Attachment 3 – HDC Minutes

Meeting Minutes

Project: Brookvale Green Fast Track – 174 and 176 Brookvale Road, Havelock North

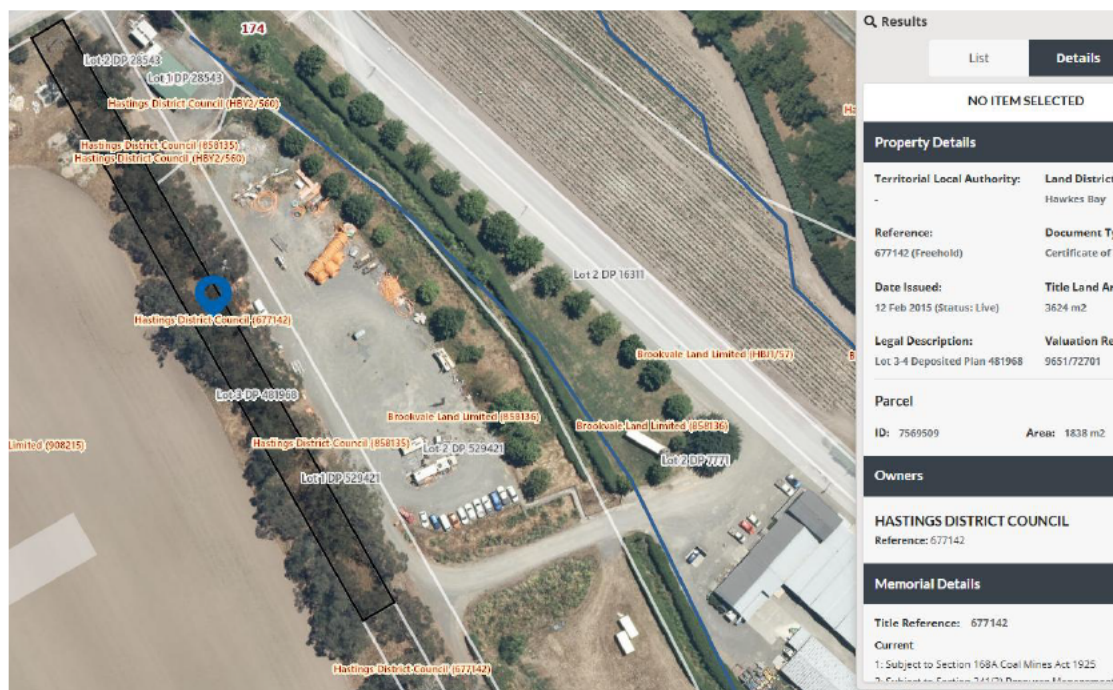
- (d) [redacted] queried whether that was 500m as the crow flies – see image above. [redacted] confirmed that it was. [redacted] noted that in actual terms in terms of access via existing roads and connections that Meissner Road would be closer to 1.5km away from Brookvale Green.
